INFORMATION NOTICE

NUMBER: 600870-000042
 SUBJECT: STRATUS ES/ESG SQUITTER FAILURE INFORMATION NOTICE
 COMPLIANCE LEVEL: OPTIONAL
 DATE: 6/04/2021

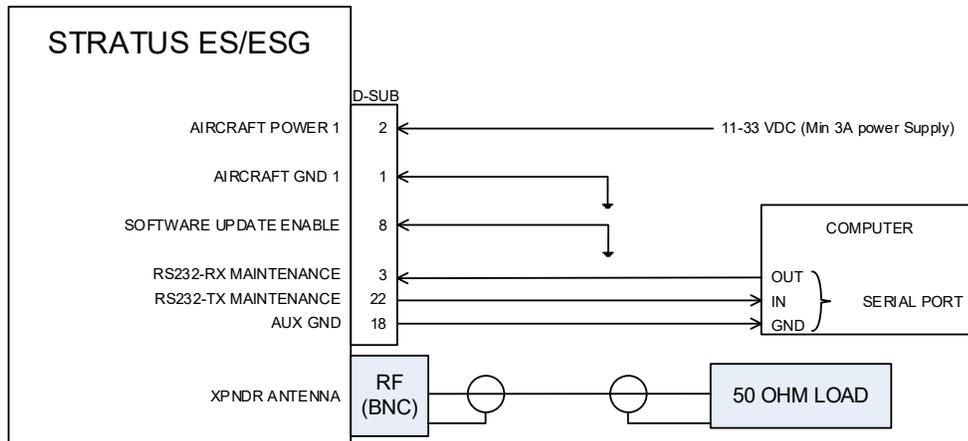
1. Use the following diagram to wire the transponder for the update.

SOME DETAIL IS REMOVED FOR CLARITY
 1 UNLESS OTHERWISE SPECIFIED, ALL WIRING TO BE DONE WITH 22 AWG WIRING
